UNITED STATES PATENT AND TRADEMARK OFFICE

APPLICATION NO.	FILING DATE	FIRST NAMED INVENTOR	ATTORNEY DOCKET NO.	CONFIRMATION NO.
10/675,520	09/30/2003	Henning Gold	JAA 216T2	6103

Office Action Summary

DETAILED ACTION

Fig. 8

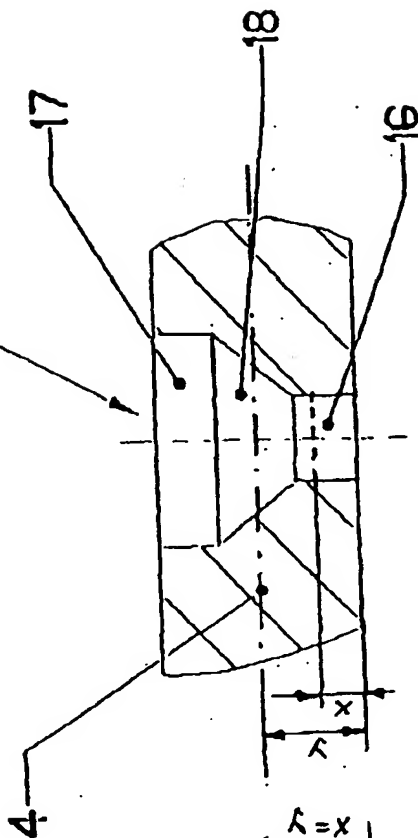
3. The drawings are objected to under 37 CFR 1.83(a). The drawings must show every feature of the invention specified in the claims. Therefore, the first, second, and third bore-holes as now claimed in claims 18-24 must be shown or the feature(s) canceled from the claim(s). No new matter should be entered.

Due to the numerical identification of the "bore-holes" it becomes unclear exactly what structure applicant considers to be the "first, second and third tapered bore-holes" in the drawings, although it appears these claims are directed to figures 3 or 8.
